PUBLIC STORM DRAIN STANDARDS

SD STANDARDS CHANGE TYPE COLOR KEY

II. PUBLIC STORM DRAIN STANDARD DETAILS

STD - 400

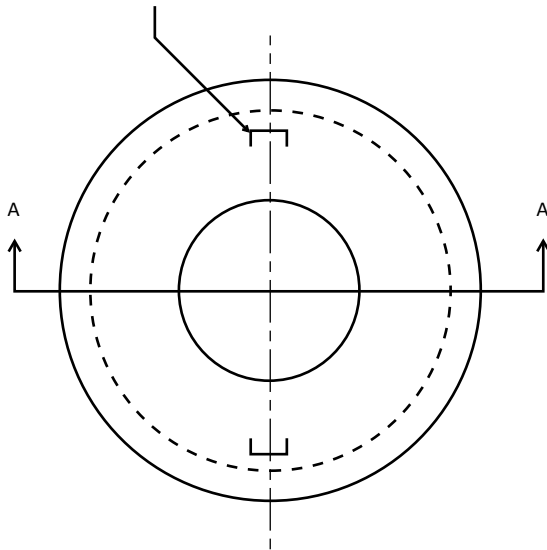
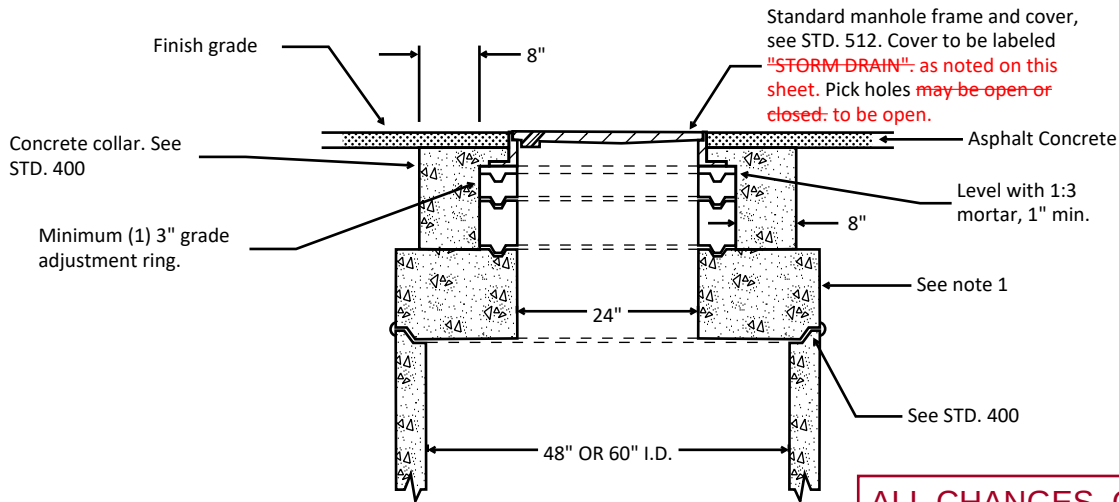
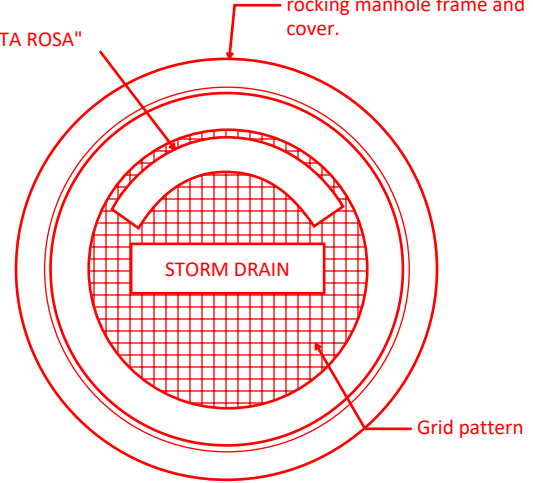
ALL CHANGES
ON THIS SHEET
PROPOSED
FOR
OPERATIONS &
MAINTENANCE

CITY OF SANTA ROSA
PRECAST CONCRETE STORM DRAIN MANHOLE REDUCER SLABS

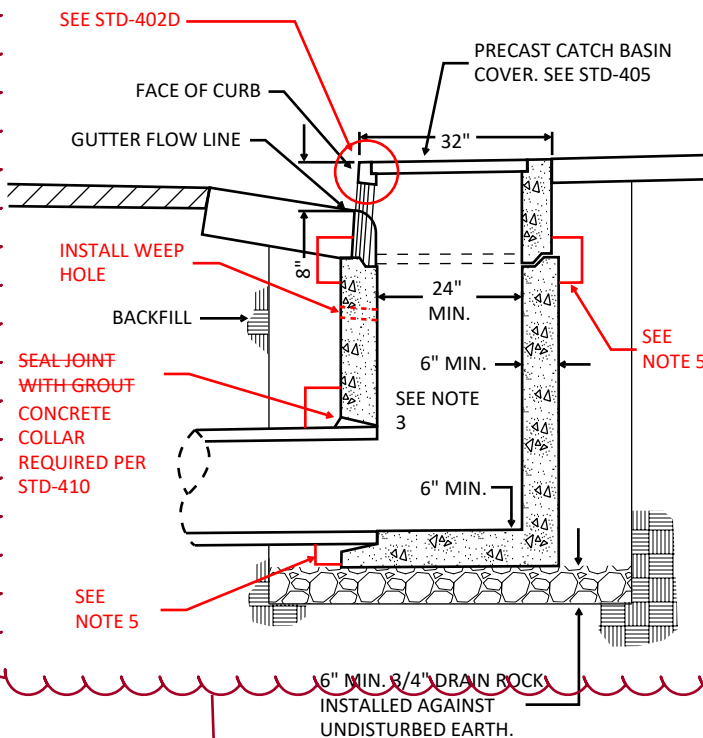
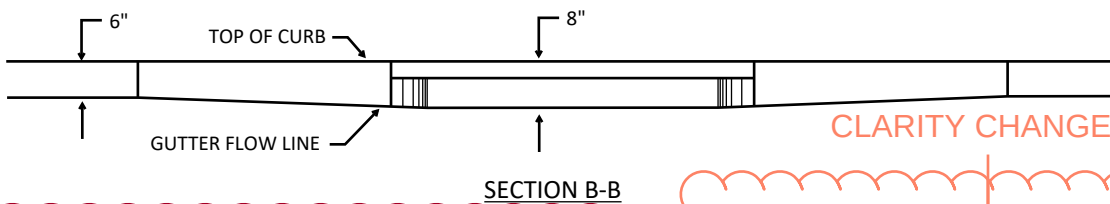
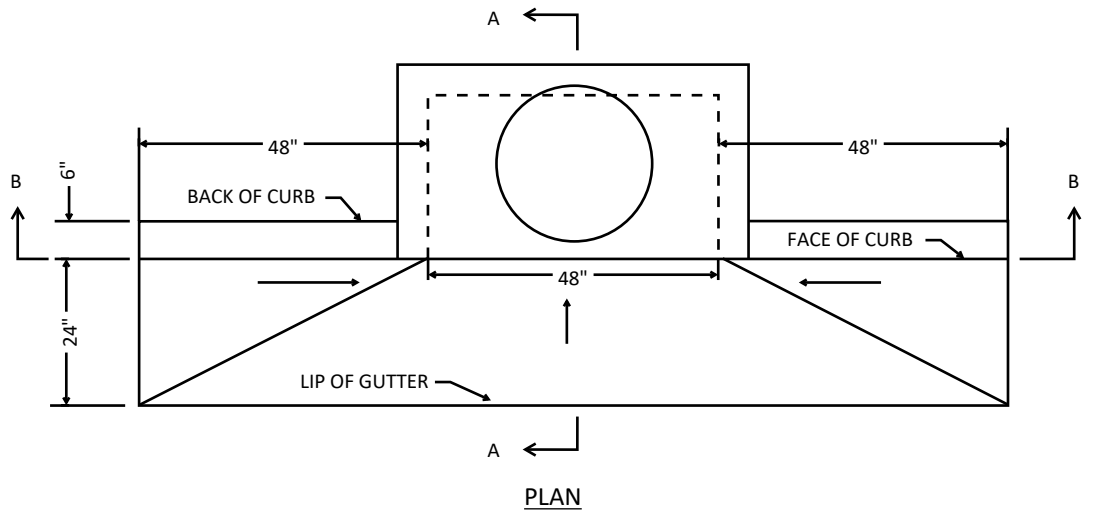
ALL CHANGES ON THIS SHEET PROPOSED FOR OPERATIONS & MAINTENANCE

Standard manhole frame and cover, see STD. 512. Cover to be labeled "STORM DRAIN": as noted on this sheet. Pick holes may be open or closed: to be open.

FILE NO:
STD - 402A

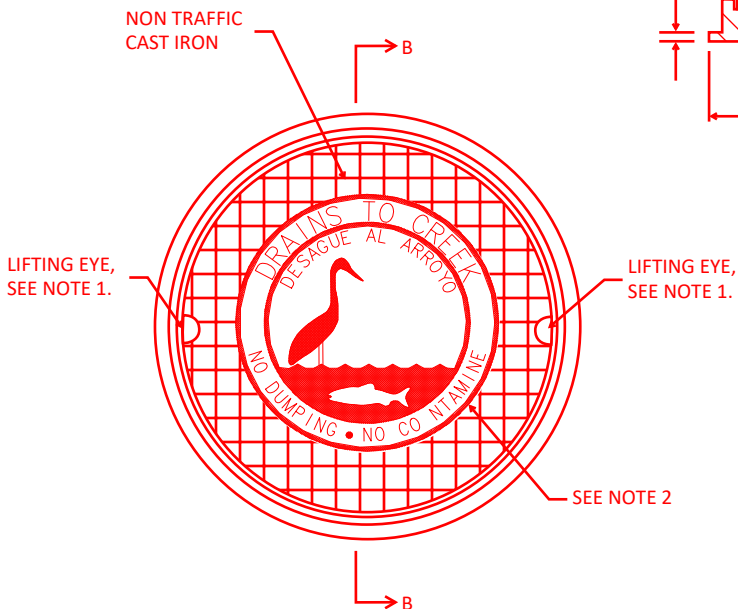
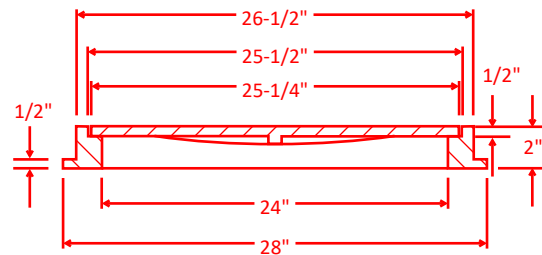
ALL CHANGES ON
THIS SHEET
PROPOSED FOR
OPERATIONS &
MAINTENANCE

1. Include total of two open #5 lifting eyes to be located at balance point. Lifting eyes shall not be blocked by the rim and shall pass through width of lid.
2. When "DRAINS TO CREEK" modification is not available, affix label per STD-409.

<i>CITY OF SANTA ROSA</i>		
<i>TYPE II CATCH BASIN</i>		
<i>Scale: NONE</i>	<i>DRAFT MARCH 2025</i>	
<i>DWN: EDS</i>	<i>APPROVED:</i>	<i>FILE NO:</i>
<i>CHK:</i>		<i>STD - 402C</i>

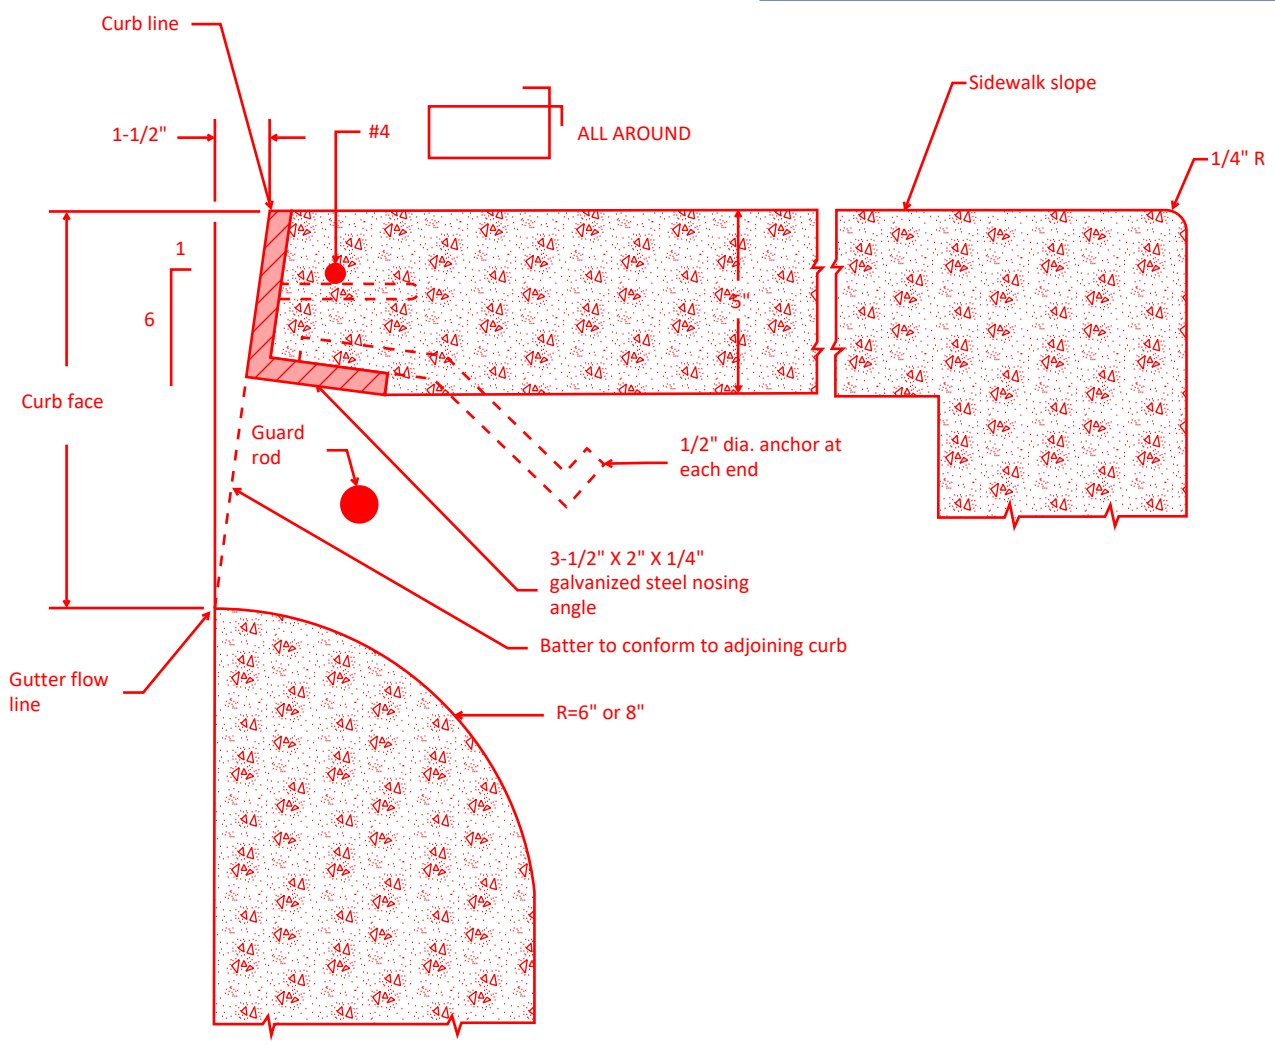
ALL CHANGES ON THIS SHEET PROPOSED FOR INDUSTRY AND CLARITY UNLESS OTHERWISE NOTED

1. Floor shall be poured and approved prior to pouring of the top.
2. See STD-402E for additional notes.

PRECAST CATCH BASIN COVER

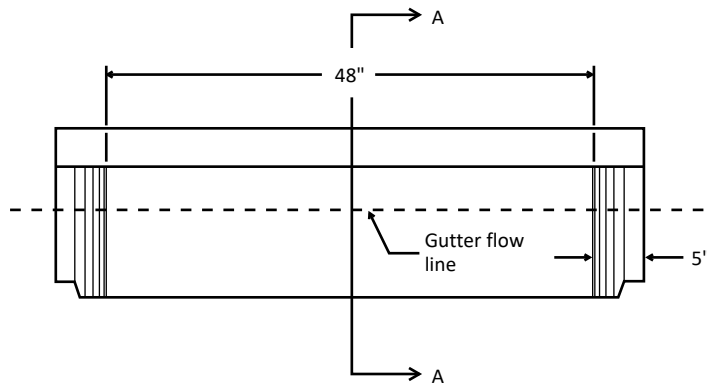
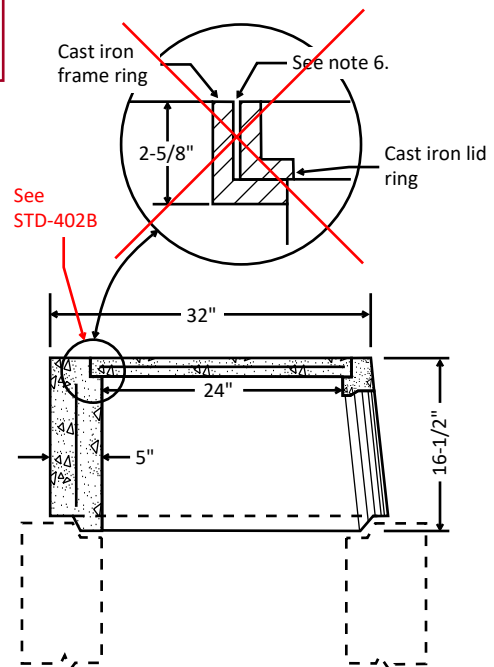
**ALL CHANGES ON THIS SHEET PROPOSED
FOR OPERATIONS & MAINTENANCE**

1. Concrete shall have a compressive strength of 4000 PSI at 28 days
2. Nosing angle shall be galvanized in accordance with ASTM specification A-123.
3. Exposed concrete surface shall have broom finish.
4. Cast iron shall conform to ASTM 48-30.
5. Apply label per City STD-409.
6. Frame ring inside diameter to be 5/16" to 3/8" greater than lid ring outside diameter.

3" SIDEWALK DRAIN

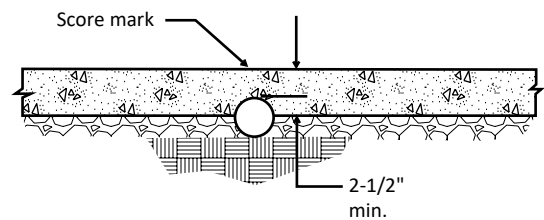
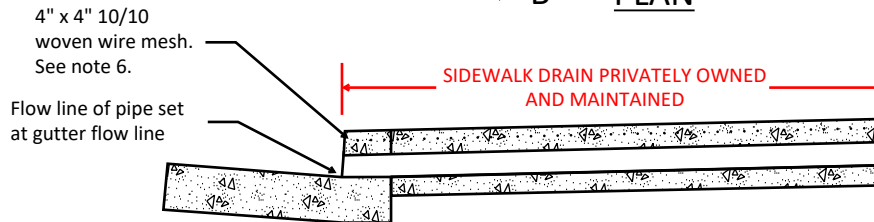
ALL CHANGES ON
THIS SHEET
PROPOSED FOR
CLARITY

1. Wire mesh shall be full width of sidewalk minus 2". Length of wire mesh shall, at a minimum, equal the width and be centered over the pipe.
2. On-site drainage and location of curb outlets shall be by owner to the satisfaction of the City Engineer.
3. Drain pipe shall be installed so that the top of pipe is 2-1/2" (min.) below finished grade at back of sidewalk.
4. Sidewalk shall be removed to the nearest scoremark.
5. If sidewalk and gutter are not contiguous, curb may be cored or curb and gutter removed and replaced a minimum of one foot on each side of the drain pipe. Dowel new gutter to existing curb and gutter with (2) 12" #4 rebars, place one dowel in curb and one in gutter pan using epoxy.
6. If sidewalk and gutter are contiguous, pour monolithic with wire fabric extending into curb.

STD - 406C

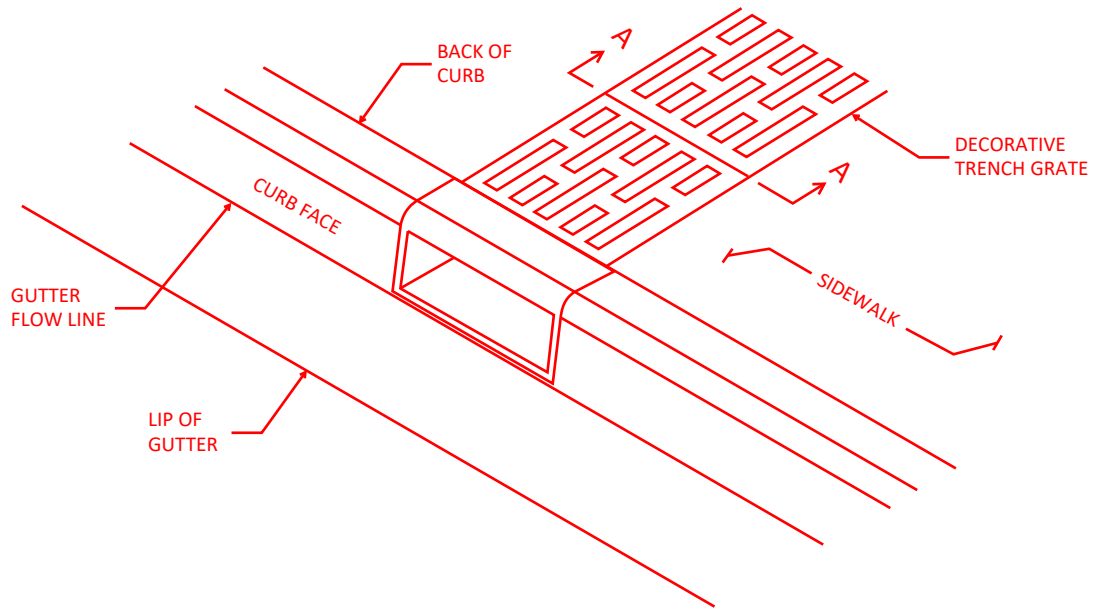
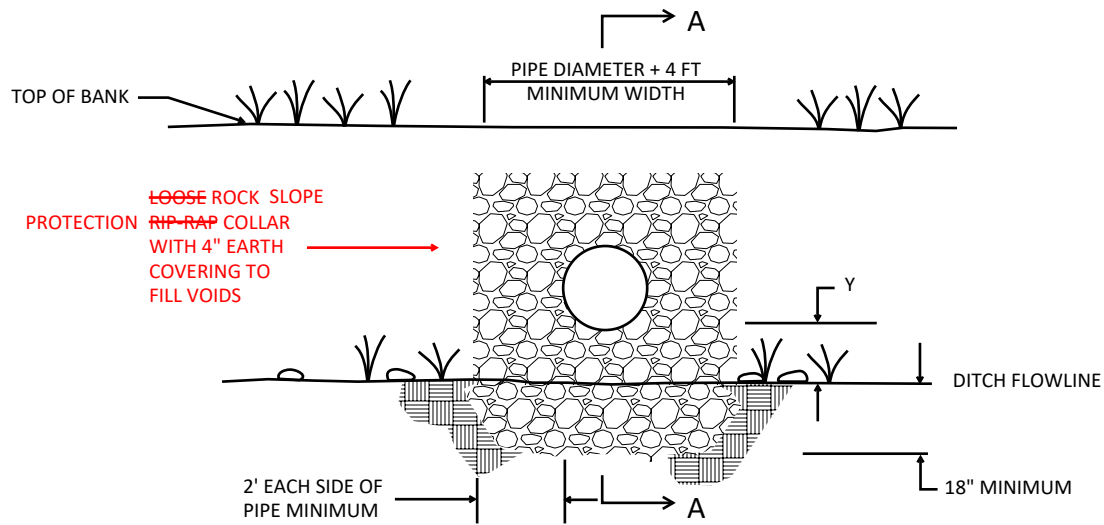
ALL CHANGES ON THIS SHEET
PROPOSED FOR INDUSTRY

STD - 412

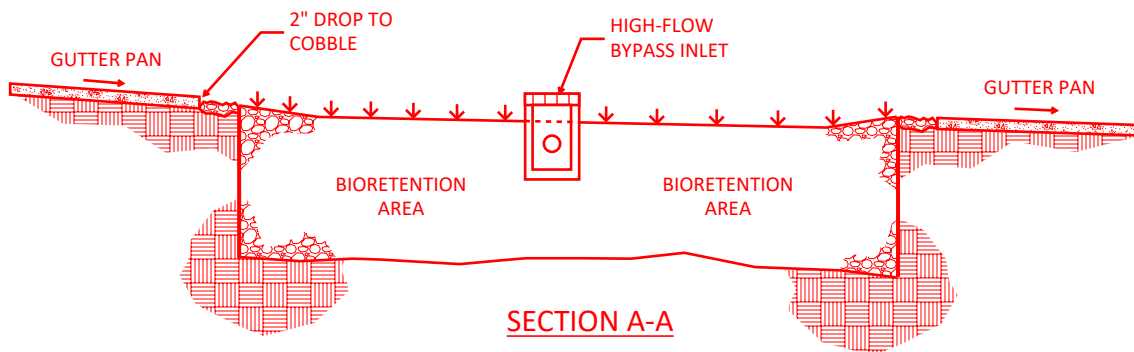
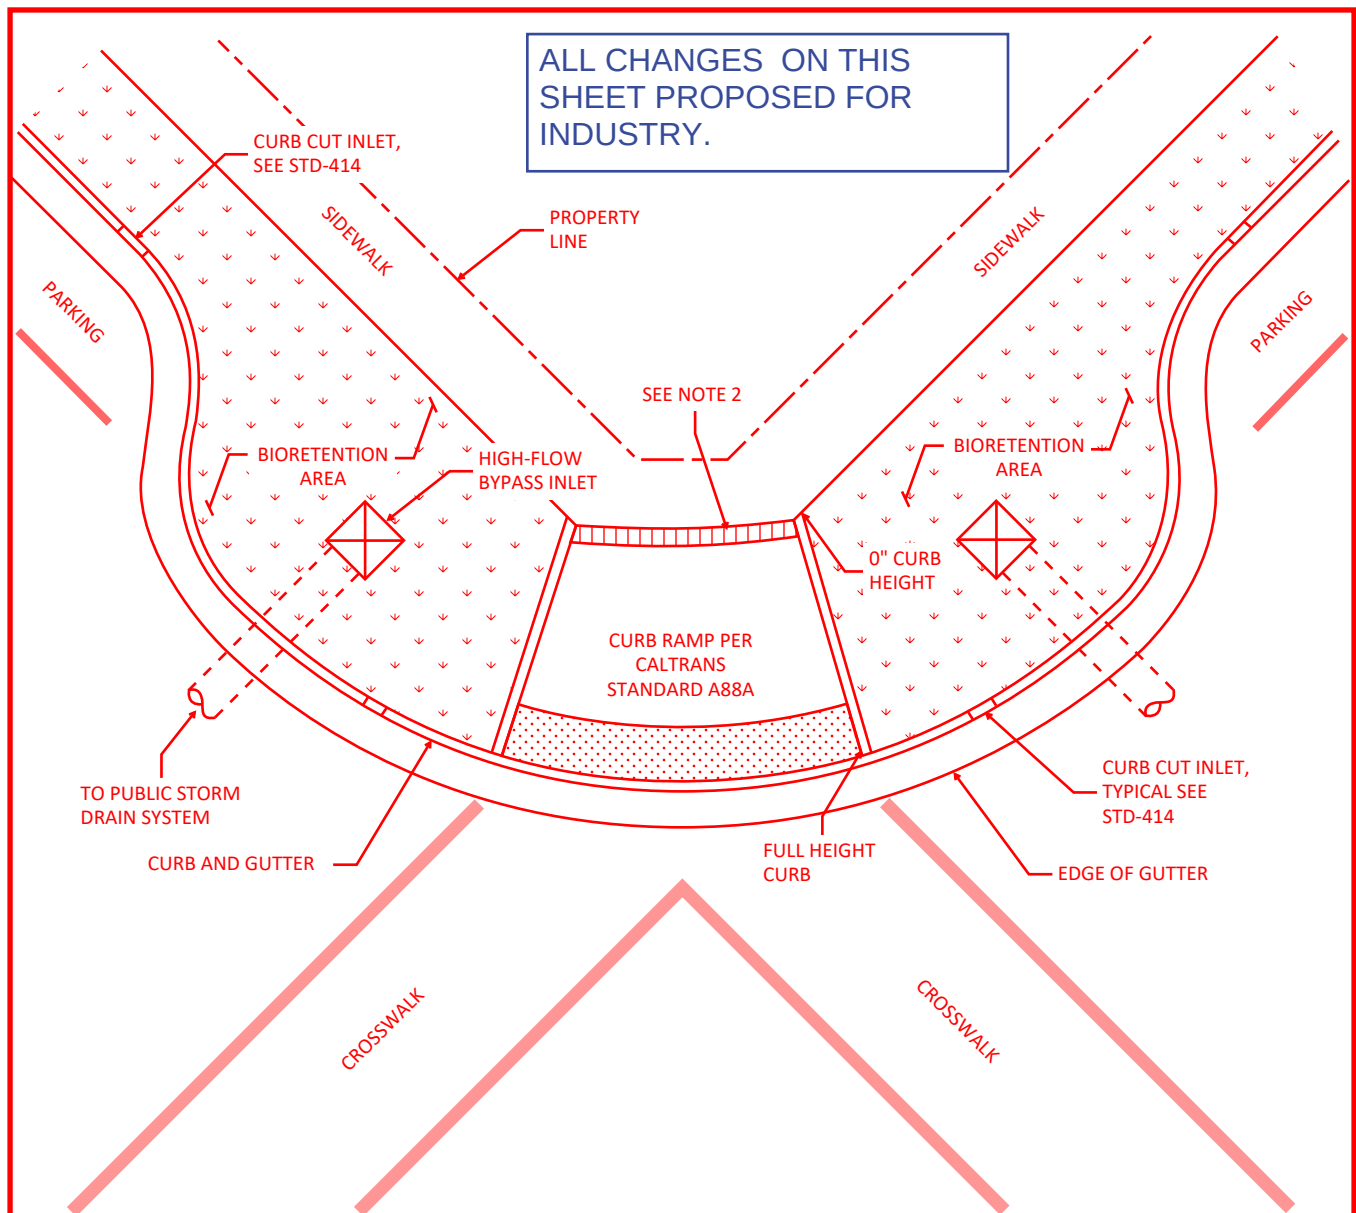
ALL CHANGES ON THIS SHEET PROPOSED FOR INDUSTRY.

1. This standard detail assumes gradual longitudinal and cross slopes of the roadway. Steeper slopes in either direction will impact conveyance and elevation differences between the facility and adjacent roadway, curb, and sidewalk surfaces. Retrofit projects will face greater constraints than new construction. Site specific design is critical to avoid grade conflicts and maximizing ponding area. Grading plans that provide spot elevations across the entire facility and along adjacent surfaces are necessary.

STORM DRAIN UNDER CURB OR PLANTER

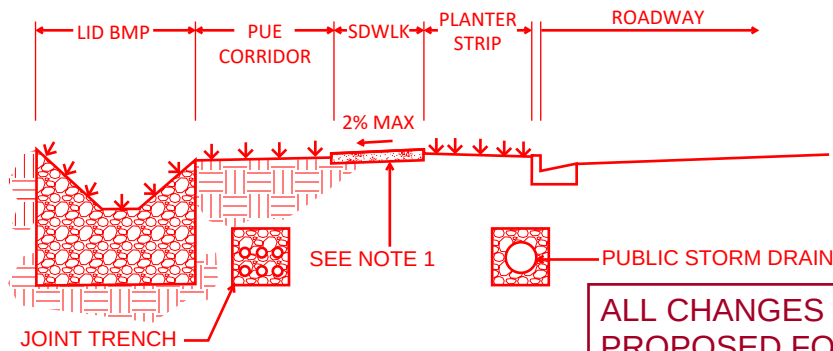
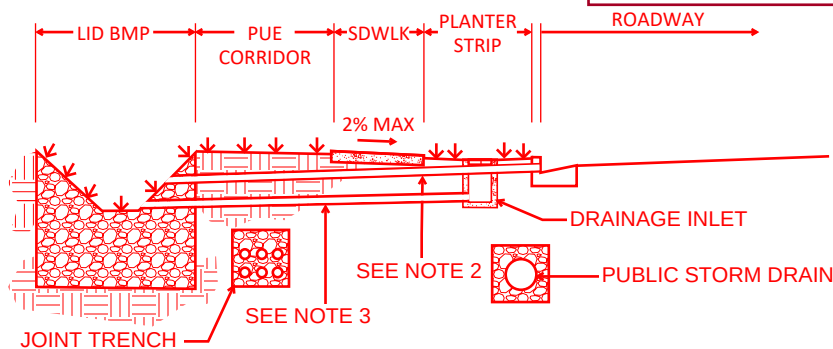
ALL CHANGES ON THIS SHEET PROPOSED FOR OPERATIONS, MAINTENANCE, AND GOVERNMENT REGULATIONS.
